## Staff Report to the Planning Commission

Application Number: **05-0252**

**Project Description:** Proposal to combine Assessor's Parcel Numbers 030-061-18 and 030-061-20, to transfer about 28,102 square feet from APNs 030-061-18 and 20 to APN 030-061-19, to construct two self-storage buildings on APN 030-061-18 & 20, to construct a car dealership on APN 030-061-19, to grade about 16,000 cubic yards, to increase the number of signs and exceed the 50 square foot size maximum, to rezone the properties from the C-2 zone district to the **C-4** zone district, and to amend the General Plan to change the General Plan land use designation from C-C (Community Commercial) to C-S (Service Commercial).

| SHEET NO. 1<br>TOTAL SHEETS: 1  | DATE: 06/06/06<br>BY: [Name] |

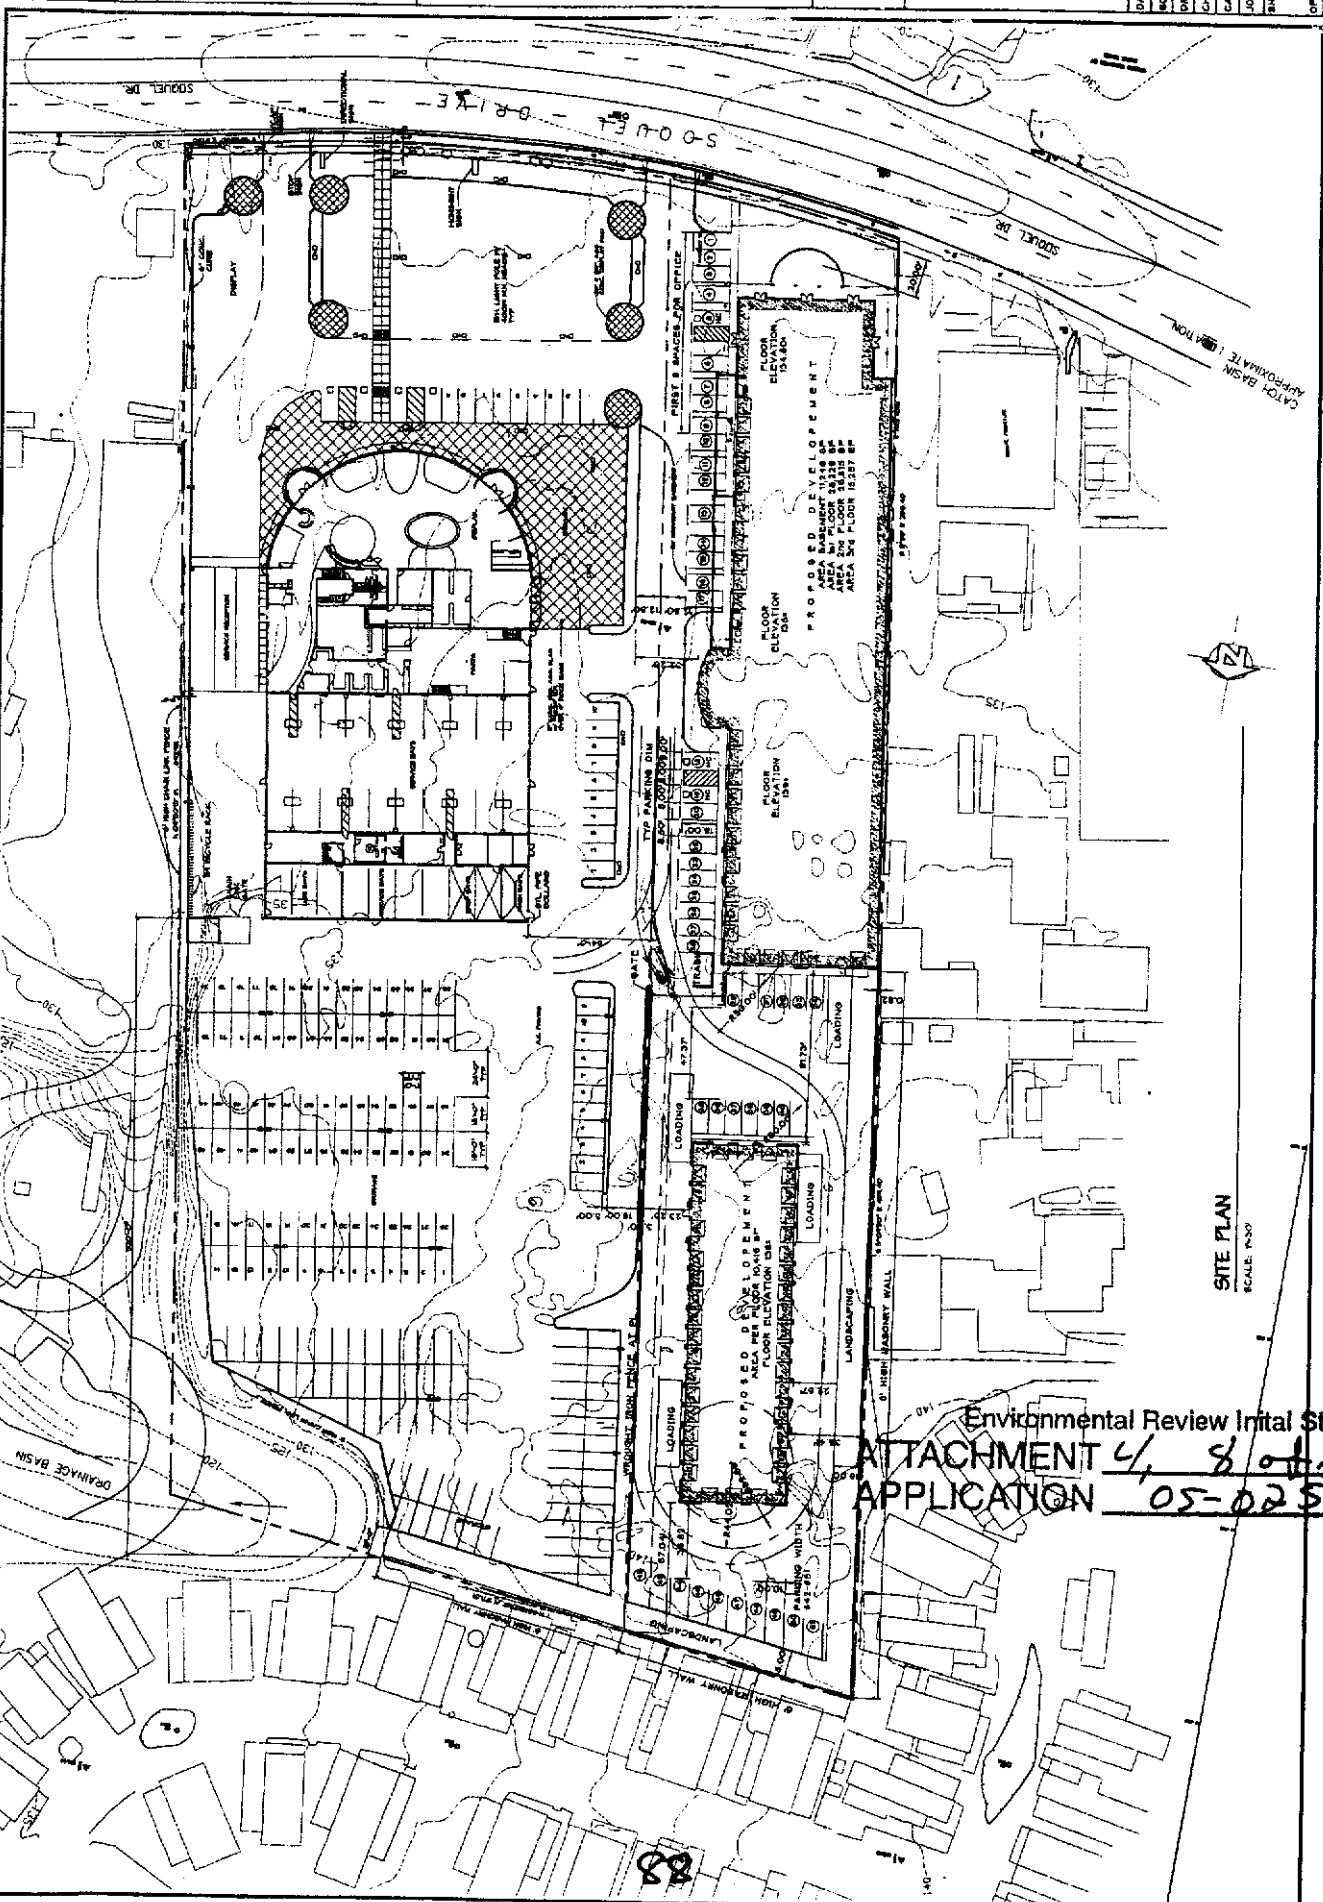
D) Location of detail 9/C7 does not show on the plan sheets.

Prior item D) Location of detail 9/C7 does not show on the plan sheets

D) Location of detail 9/C7 does not show on the plan sheets

Prior item D) Location of detail 9/C7 does not show on the plan sheets.

Exterior Elevations  
A-4  
8

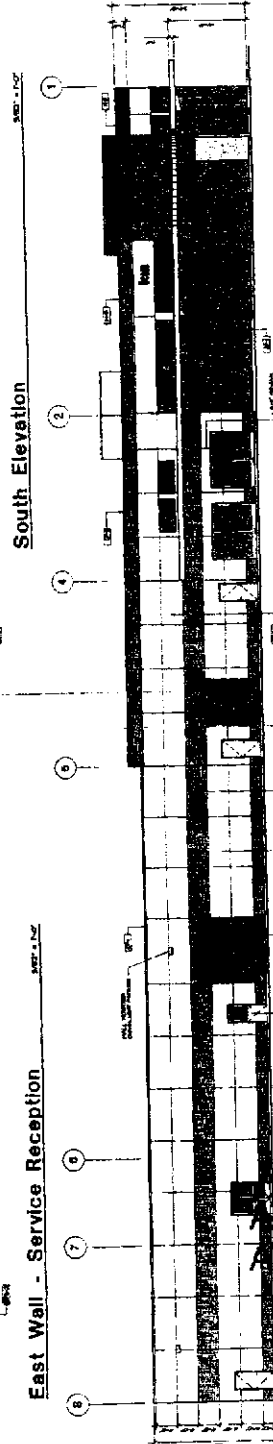
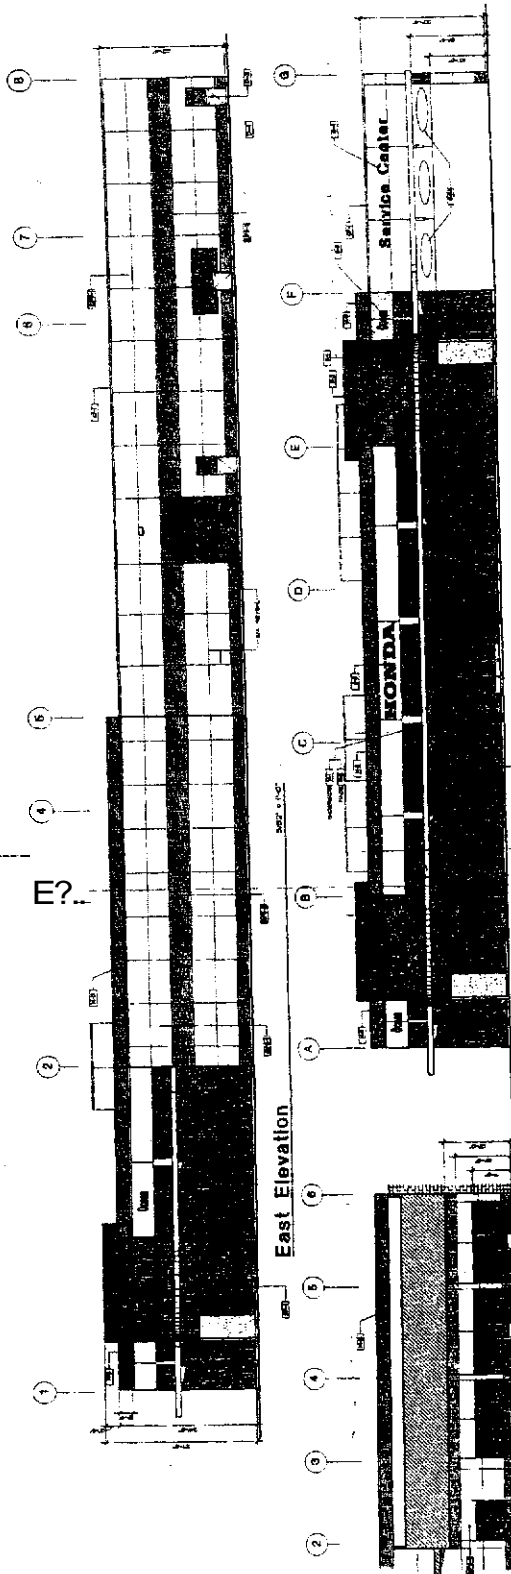
Sheet L-1 indicates a sound wall only on a portion of the rear of the Honda Dealership while Sheet A-1, Site Plan, indicates this 6 foot masonry sound wall to continue along the northern and western rear of the Store More America buildings. Will all plan sheets be revised accordingly to indicate the sound wall in total?
